Intel® Technical Advisory

TA-901-1

3/19/2008

Hard disks may not initialize if only two disks are installed in the Intel® Entry Storage System SS4200-E

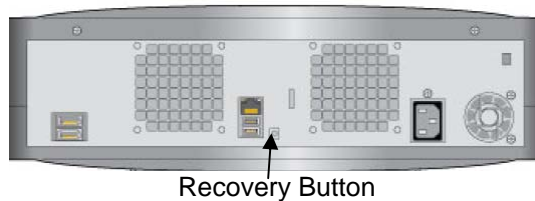
When installing only two hard disk drives in the Intel® Entry Storage System 4200-E, the drives may be identified in "parity" mode instead of "mirror" and will not initialize. A message in the GUI will state "Data on your storage device is currently unavailable". The power button LED will illuminate, and stay, amber.

Some systems may have been set for a four drive configuration during factory test.

Install four drives into the storage system or proceed with the workaround.
This issue will be fixed in a future software release.

1. Install two drives into drive retention brackets numbered 1 and 2 as described in the user guide.
2. Connect power cable to storage system.
3. Press and hold the Recovery Button, located on the back of the system, while powering on the storage system (press, then release the power button on the front panel).

4. After a short delay, the front panel power indicator LED and drive LEDs will flash three or four times in unison then stop.
5. After the LEDs have stopped flashing, release the reset button and allow the system to reboot. This process may take longer than normal due to the reset process of the system software.
6. Follow the instruction to load the client storage system software and configure the storage system.
